Customer Satisfaction Program

44290 Rear Door Laminated Glass

Reference Number: N162044290
GWM Number: 2044290
Revision Description: This bulletin was revised to add an inspection procedure. Please discard all previous copies of bulletin 44290.

Release Date: September 2016
Revision: 01

4583338

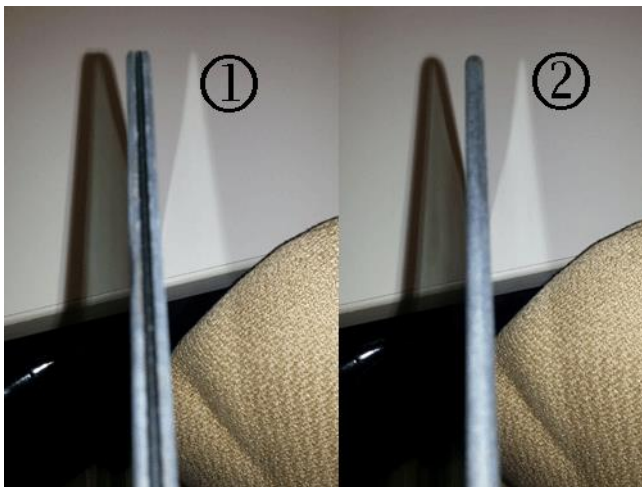
1. Inspect both rear side door windows:

- If the rear door windows have laminated glass (1) installed, no further action is required.
 - If the rear door windows have tempered glass (2) installed, proceed to step 2.
2. Replace both rear side door windows. Refer to *Rear Side Door Window Replacement* in SI.
